**AGENDA
HISTORIC PRESERVATION
CITY HALL COUNCIL CHAMBERS
109 EAST OLIVE STREET; BLOOMINGTON, IL 61701
THURSDAY, FEBRUARY 20, 2020 at 5:00 P.M.**

CASE NO:	TYPE:	ADDRESS	SUBJECT:	REPORT BY:
BHP-05-20	Rust Grant	113 W. Front St.	Rehabilitate facade	Casey Weeks, Assistant City Planner

CASE NO:	TYPE:	ADDRESS	SUBJECT:	REPORT BY:
BHP-06-20	Funk Grant	410 E. Walnut St.	Replace roof	Casey Weeks, Assistant City Planner

Figure 5 Proposed replacement windows at 113 W. Front St. will match the ones pictured here at 115 W. Front Street.

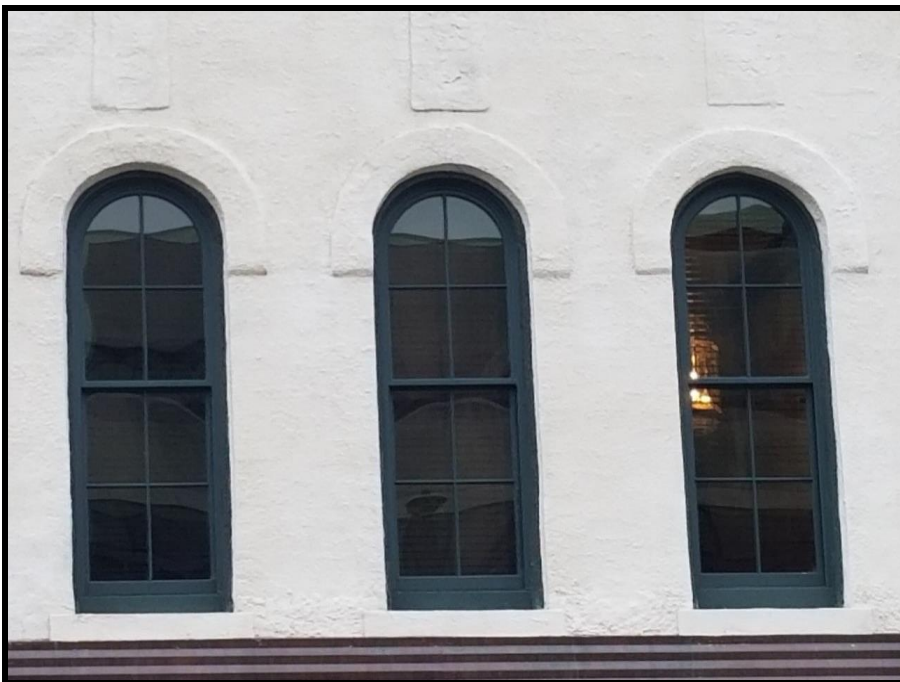
According to the architect's specifications, the arched windows will be "Marvin, Pella or others, manufactures of Commercial/Residential Windows: Double Hung, Aluminum exterior covering, wood interior finish. If possible, factory applied finish exterior color, insulated glass, 3/8" thick, UV protection. Verify size to closely match existing 3 windows on 2nd floor, Wall thickness to be 5 1/2", verify with existing wall construction, Provide wall fins for attachment. Contactor to provide flashing membrane at all perimeter surfaces of window to the wall construction, top, sides, and bottom."

a. Where new replacement windows are proposed to replace non-original windows in a building, the design and detail of the replacement window shall be based on the documented configuration of the building's original windows. Such documentation may be obtained from historic photographs, drawings, or the design of the new replacement windows may be based on window configurations typical to the period of significance of the building.
